# NONKEY TELEPHONE SETS

# CONVERSION FOR USE WITH 1A1 OR 1A2 KEY TELEPHONE SYSTEMS

1.002 This addendum is issued to revise Fig. 5.

Fig. 5-554BMP Telephone Set, Connections for Use With 1A1 or 1A2 KTS

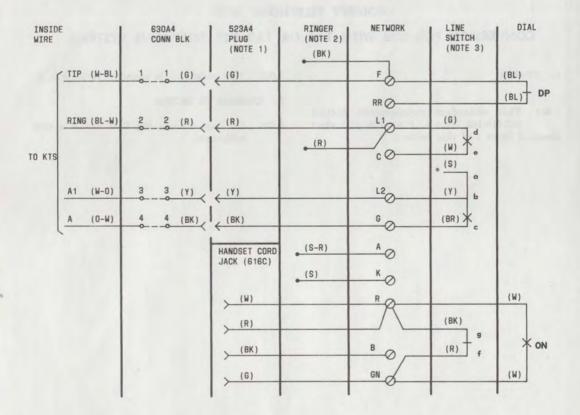
2.001 On Page 8 revise Fig. 5 as shown in this addendum.

- REPLACE 523A3 PLUG WITH 523A4 PLUG, ORDERED SEPARATELY.
- 2. WIRED FOR INDIVIDUAL OR BRIDGED RINGING.
- TO PREVENT FALSE HOLD CONDITION WHEN GOING ON-HOOK, THE TIP AND RING CONTACTS OF THE LINE SWITCH MUST BREAK BEFORE "A" LEAD CONTACTS. (FIELD ADJUSTMENT OF LINE SWITCH NOT RECOMMENDED).
- \* INSULATE AND STORE
- DP DIAL PULSE CONTACTS
- ON DIAL OFF-NORMAL CONTACTS
